## WAITSFIELD DEVELOPMENT REVIEW BOARD MEETING AGENDA

STAFF REPORT by J.B. Weir for August 13, 2024 Meeting

<b>Application #:</b>	<b>4201-CU</b>
<b>Land Owner:</b>	<b>Rookwood Properties, LLC (d/b/a Featherbed Inn)</b>
<b>Property Address:</b>	<b>5864 Main Street</b>
<b>Parcel Number:</b>	<b>99185.000 in the Agricultural-Residential District and Adaptive Redevelopment Overlay District</b>
<b>Meeting Dates:</b>	<b>December 13, 2022</b>
<b>Proposal/Type:</b>	<b>Site plan amendment to construct a 288 sq. ft. sauna (accessory structure to inn).</b>

<b>Application #:</b>	<b>SUB24-01</b>
<b>Landowner:</b>	<b>Shea Property Services</b>
<b>Property Address:</b>	<b>Main Street/Route 100</b>
<b>Parcel Number:</b>	<b>#99031.005</b>
<b>Meeting Dates:</b>	<b>Sketch Plan Review on May 28, 2024; Preliminary Plan Review / Final Plan Review August 13, 2024</b>
<b>Proposal/Type:</b>	<b>Preliminary Plan review for a subdivision of parcel #99031.005 into three lots of 22.64-acres, 1-acre and 1.06-acres. The parcel is located in the Agricultural-Residential District. *The applicants request that Preliminary Plan and Final Plan Review occur at the same hearing and has, therefore, waived their right t

Sheet Title  
**Site Plan Lots 5-7**

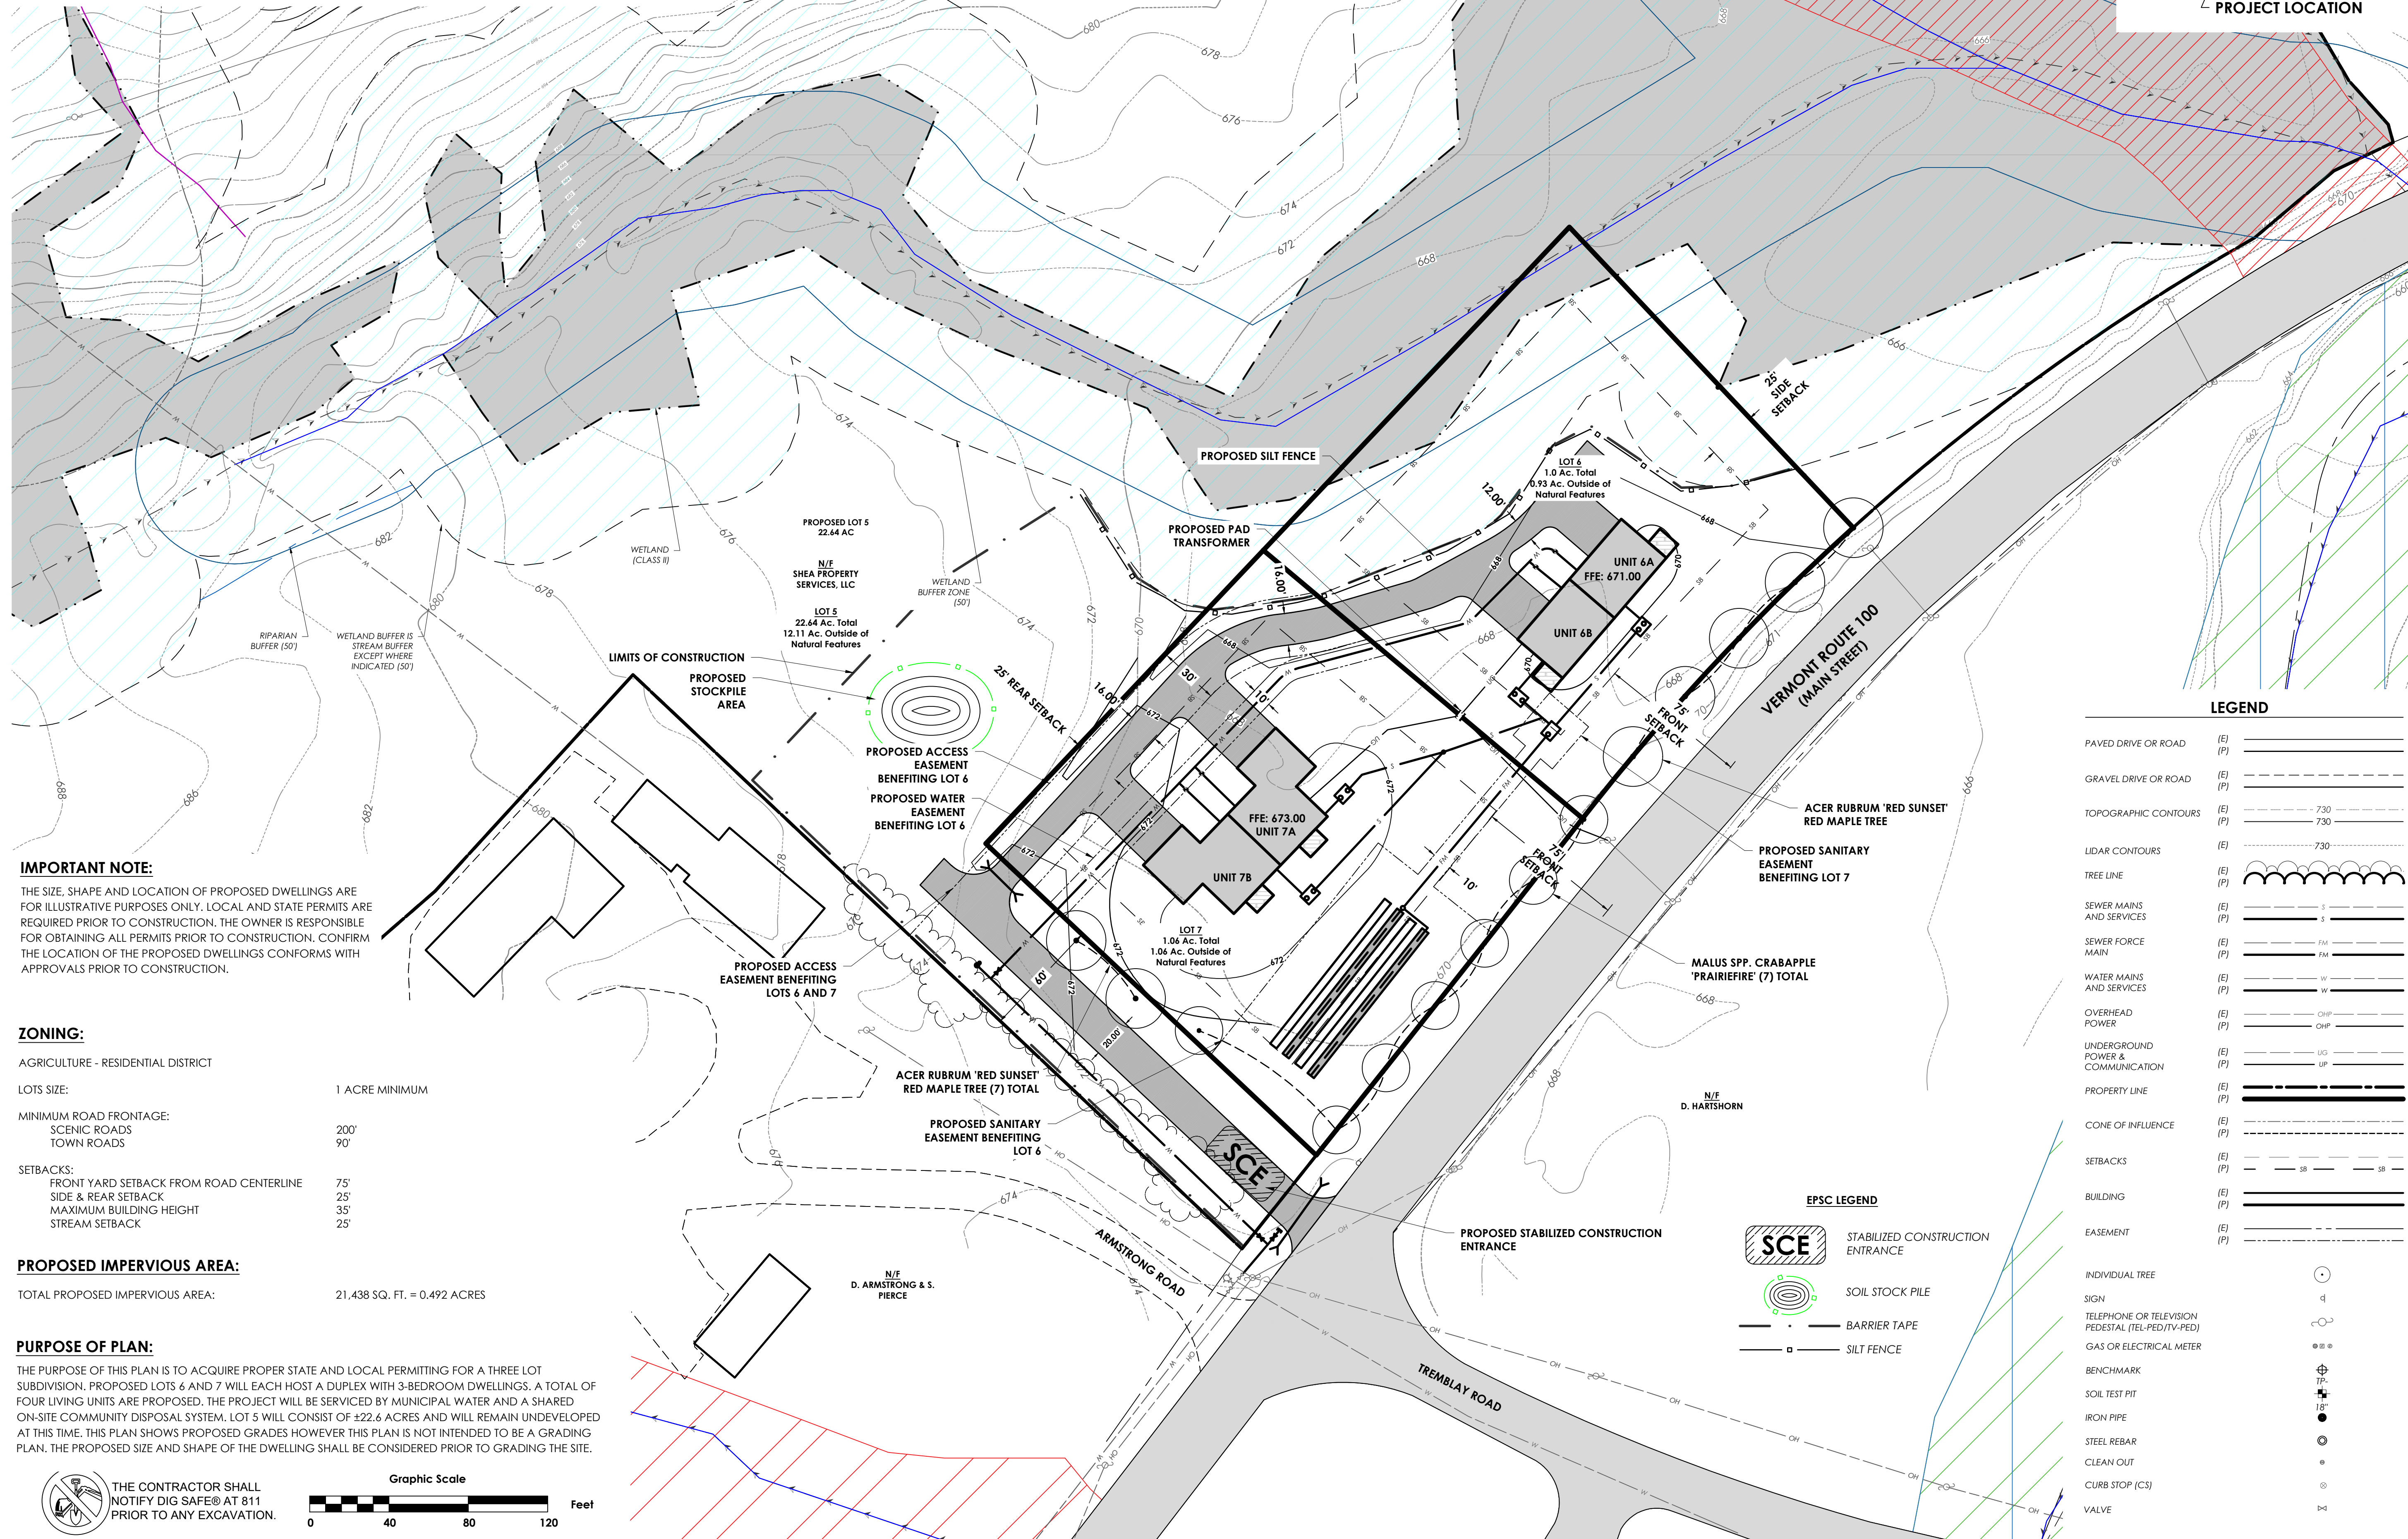
15. Per the Board's determination on Sketch Plan Review, the applicant was to submit a screening/landscaping plan for Preliminary Plan review. Sheet C2-02 delineates the types and locations of proposed vegetation.

**3-Lot Subdivision Plat**  
**Shea Property Services, LLC.**  
 Parcel ID# 99031.0  
 Center Fayston Road and Vermont Route 100  
 Waitsfield, Vermont

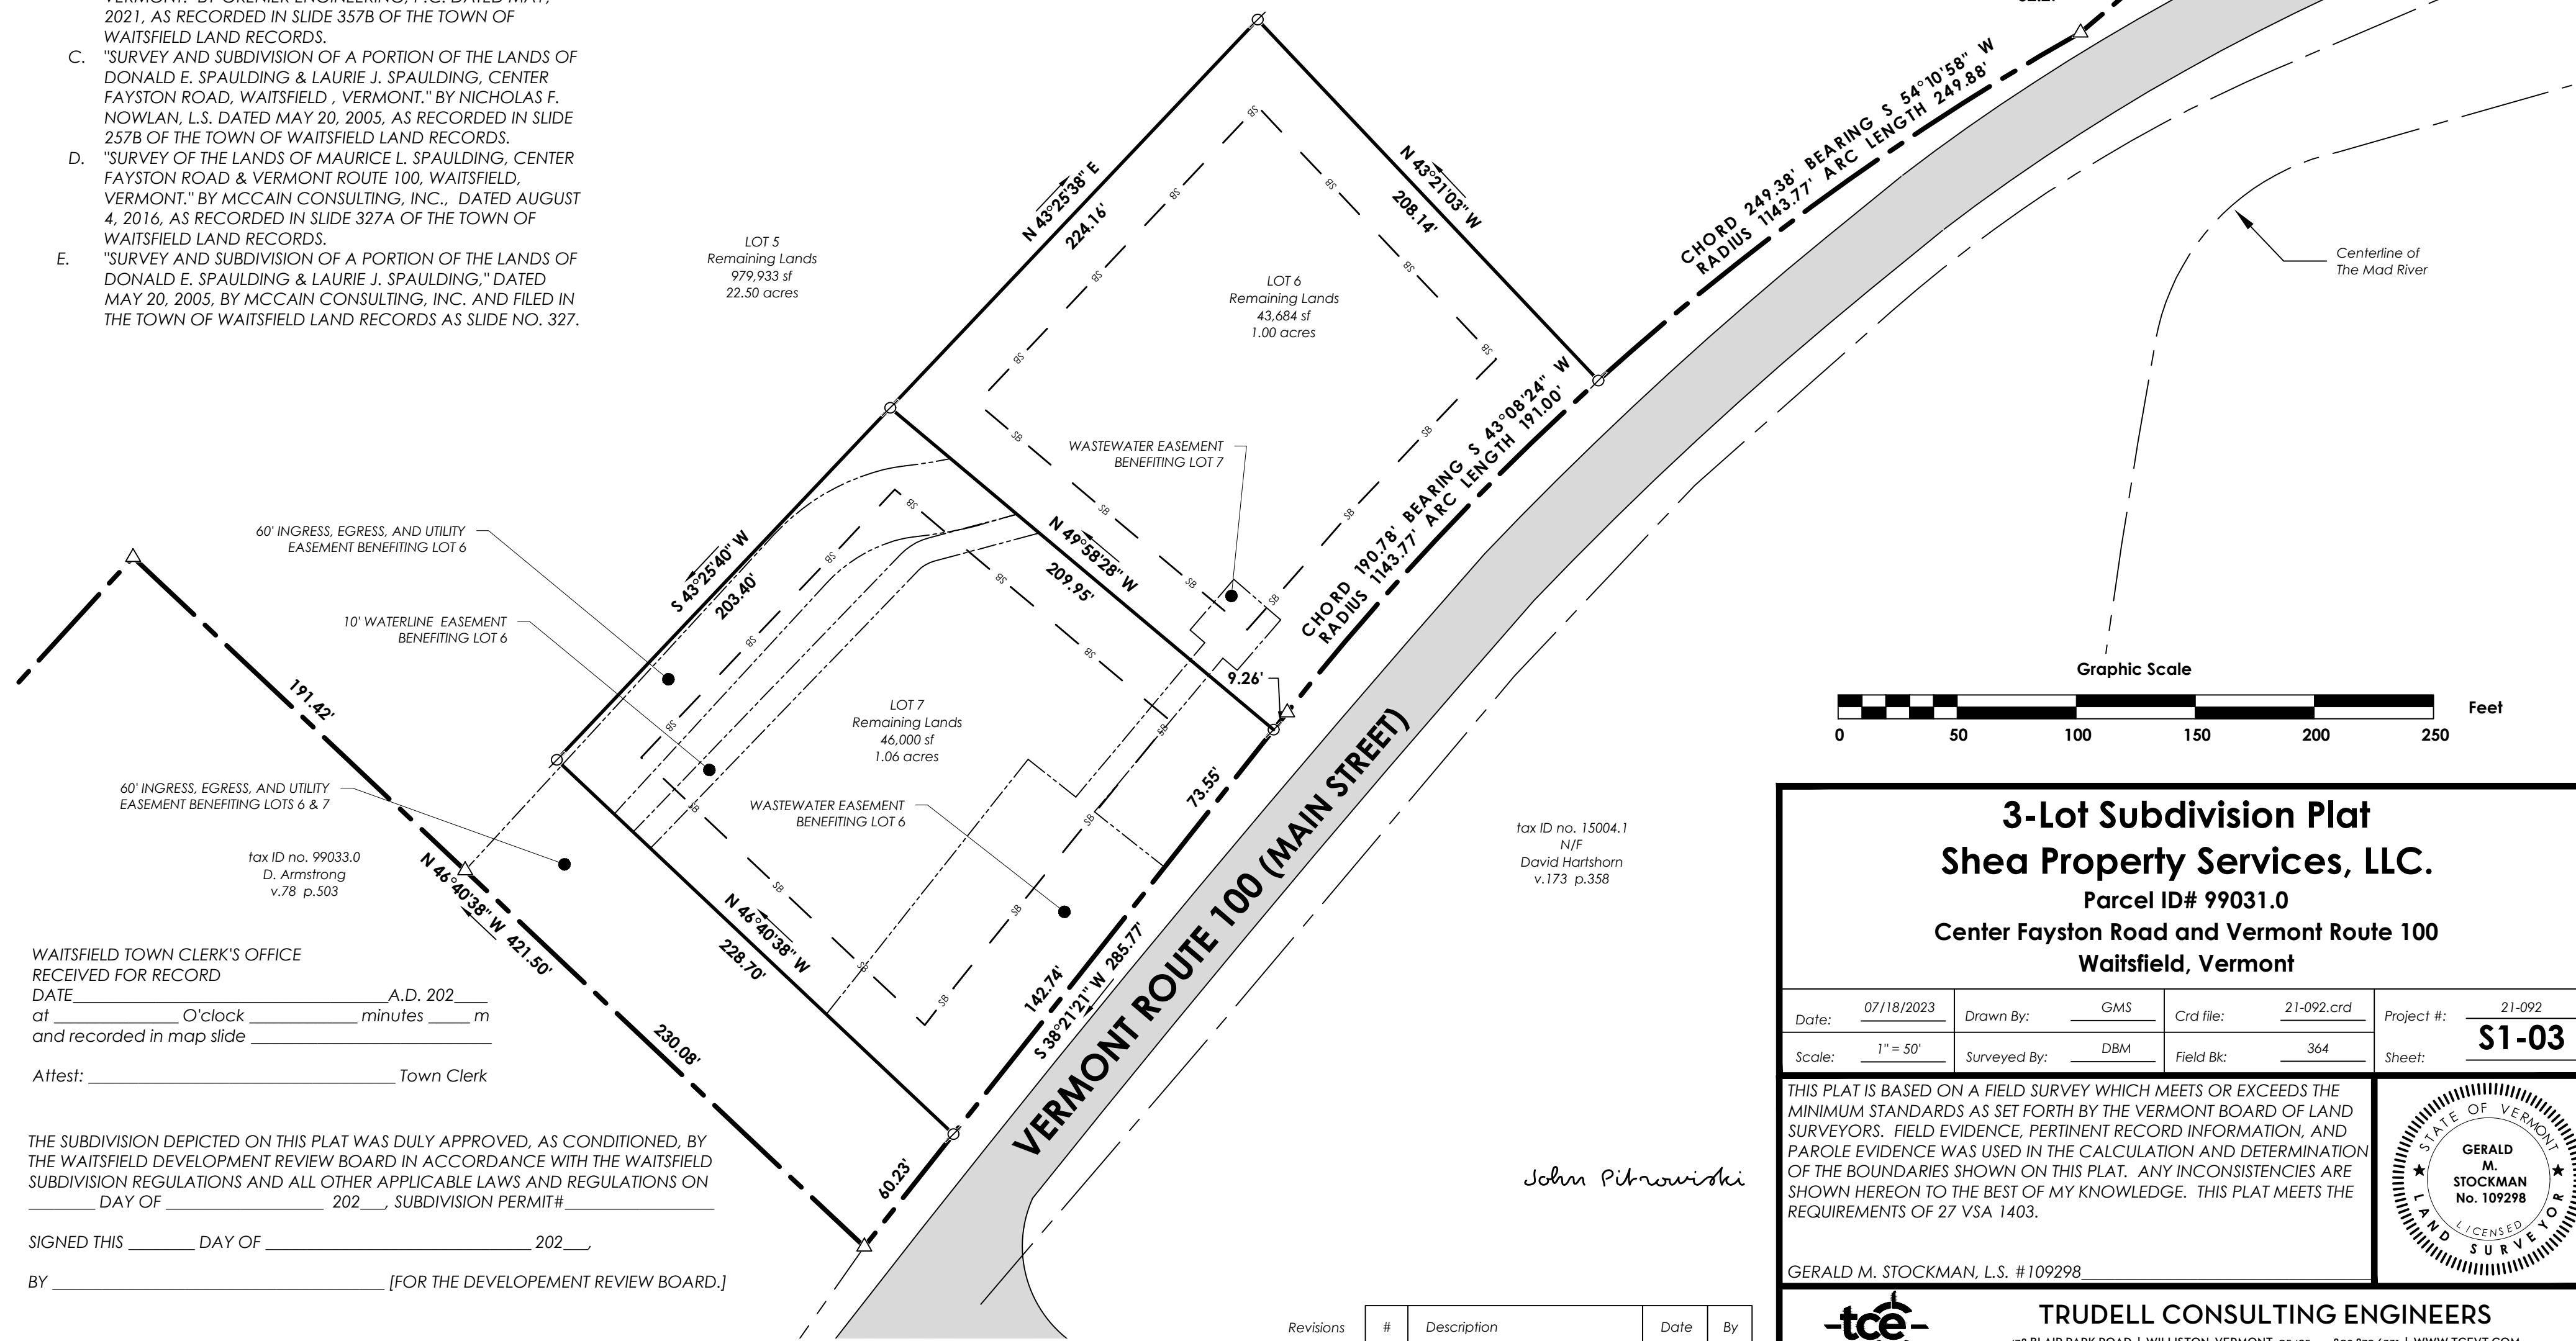
1. On July 5, 2024, applicant submitted:
  - a. Subdivision application (#Sub24-01);
  - b. Cover letter;
  - c. "3-Lot Subdivision Plat" – Sheet S1-03 (Trudell Consulting Engineers) dated 7/18/2023;
  - d. "Property Compilation Plat" – Sheet S1-02 (Trudell Consulting Engineers, dated 7/8/2022);
  - e. "Master Site Plan" – Sheet C1-03 (Trudell Consulting Engineers, dated 5/28/2024);
  - f. "Site Plan Lots 5-7" – Sheet C2-02 (Trudell Consulting Engineers, dated 5/28/2024);
  - g. "Sanitary Plan Lots 6-7" – Sheet C3-01 ((Trudell Consulting Engineers, dated 5/28/2024);
